ADDENDUM NUMBER 3 ON INVITATION TO BID ITB18KO-131

TITLE: Building 700 Renovation – Phase 2

A100
ARCHITECTURAL
PHASING PLAN

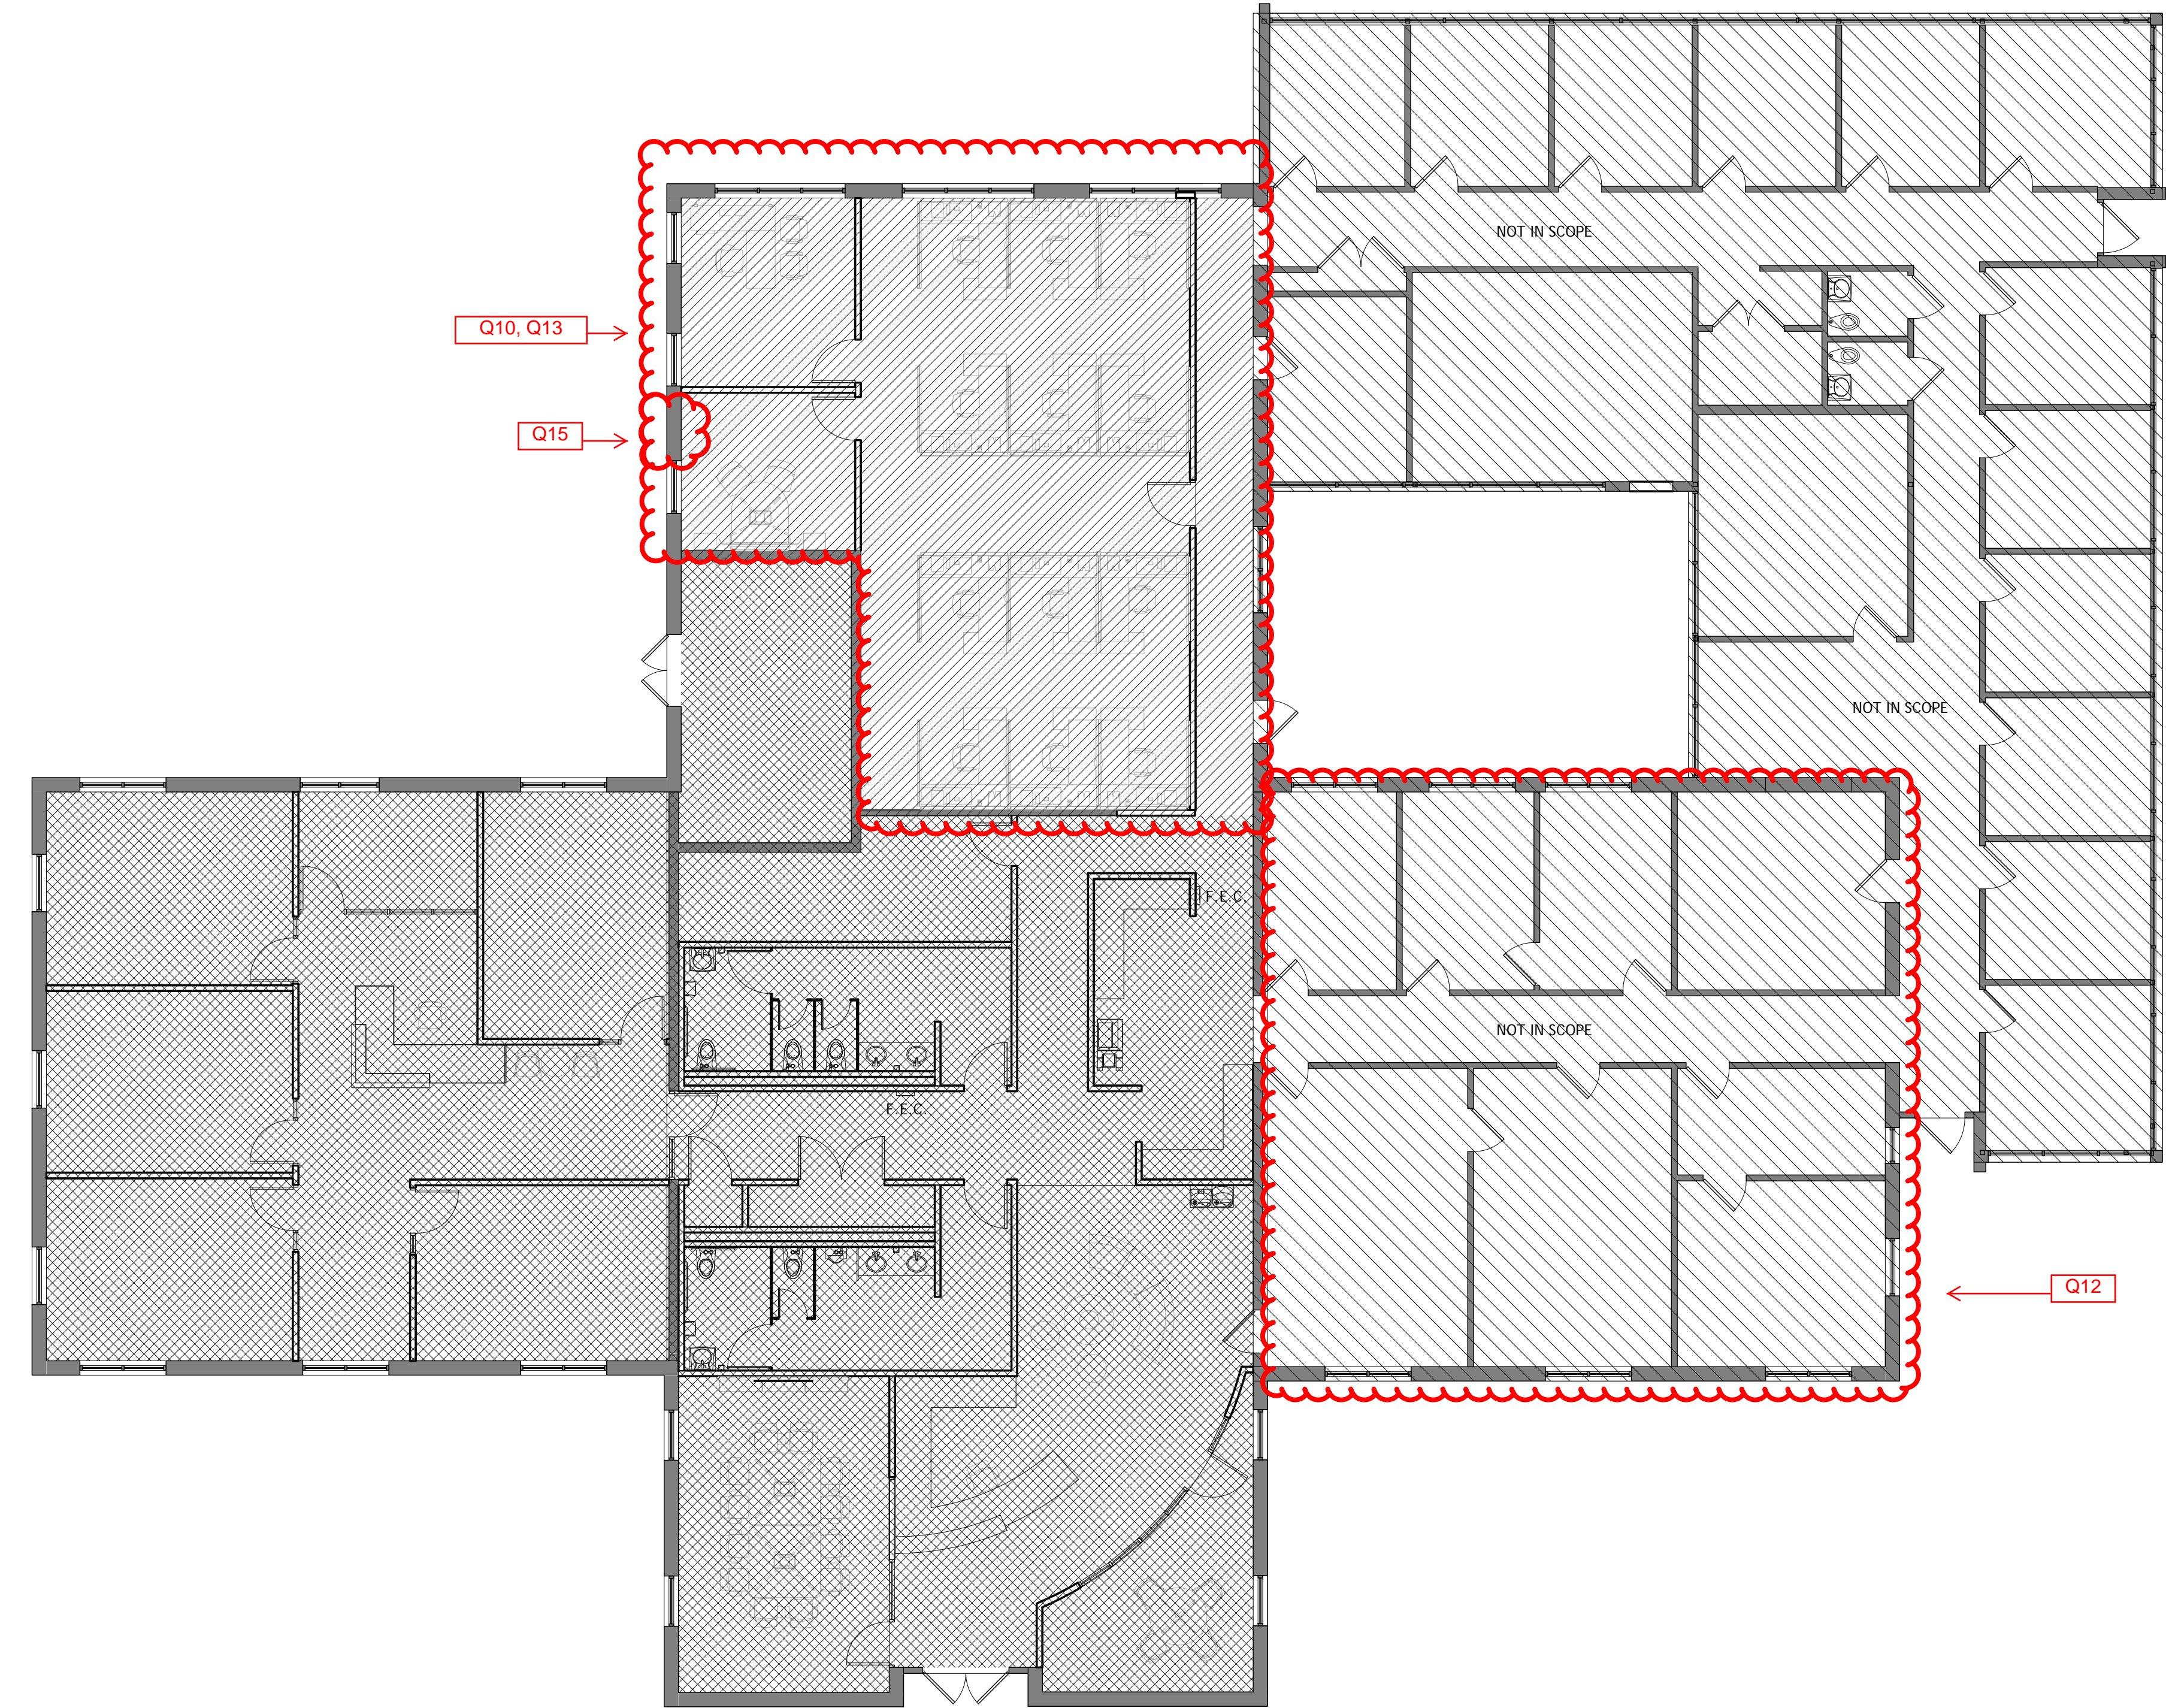
Q10. Phase 1 Work Clarification (Reference Attached Drawing)

The Conformance Documents issued with Addendum No. 1 show work in the area adjacent and North of the existing mechanical room – Phase 1 per Sheet A100 (dated 11/1/17).

Based on our observations during the walkthrough, it appeared that these areas were already renovated.

Confirm if there is any work to take place in the following rooms: O132, O131, O130, M095A, TR01A, C199B & C199D.

RFI No. 2 - Phase 1 Work Clarification

The Conformance Documents issued with Addendum No. 1 show work in the area adjacent and North of the existing mechanical room – Phase 1 per Sheet A100 (dated 11/1/17).

Based on our observations during the walkthrough, it appeared that these areas were already renovated.

Confirm if there is any work to take place in the following rooms: O132, O131, O130, M095A, TR01A, C199B & C199D.

A10. No work shall be provided in 0132 and 0131. No architectural work will be required in 0130.
